SERVICE PROCEDURE

18504
June, 2018

SUBJECT: **SAFETY RECALL**
Brake Air Line Routing on certain International®
HX® Series trucks built 08 December 2015 thru 10
February 2018 with feature code 04091 (dual air
brake system) and 04AZY (Antilock Brake System
[ABS] with 6 channel Electronic Stability
Protection [ESP])

Figure 1. ATR-6 Valve

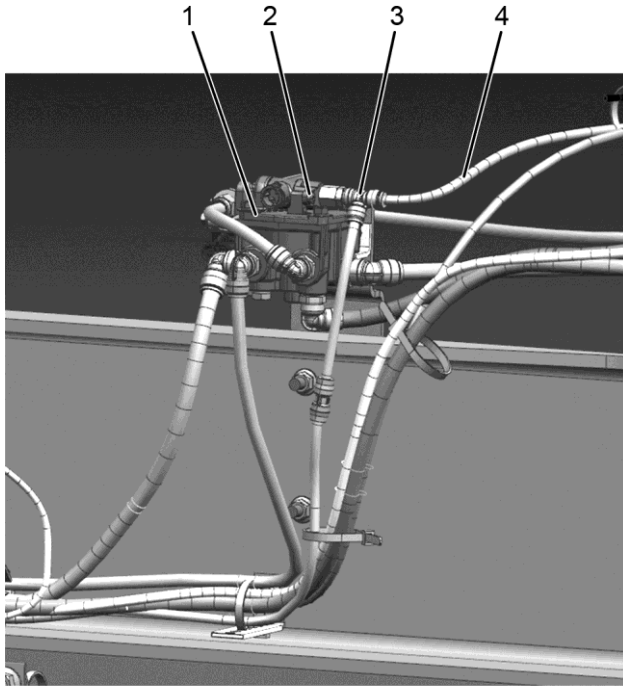
The roll stability valve air supply line may be incorrectly routed. This condition does not affect normal brake operation. However, during a stability control oversteer event and with slippery road conditions, the parking brakes may be modulated unintentionally. Modulation of the parking brake during a stability control oversteer event could lead to loss of control or a vehicle crash.

1. ATR-6 valve
 2. Control port
 3. 45-degree fitting
 4. 3/8-inch ORANGE airline
-
6. Disconnect ORANGE 3/8-inch airline (Figure 1, Item 4) from 45-degree fitting (Figure 1, Item 3) of ATR-6 control port (Figure 1, Item 2).
 7. Remove and discard 45-degree fitting (Figure 1, Item 3) from ATR-6 control port (Figure 1, Item 2).
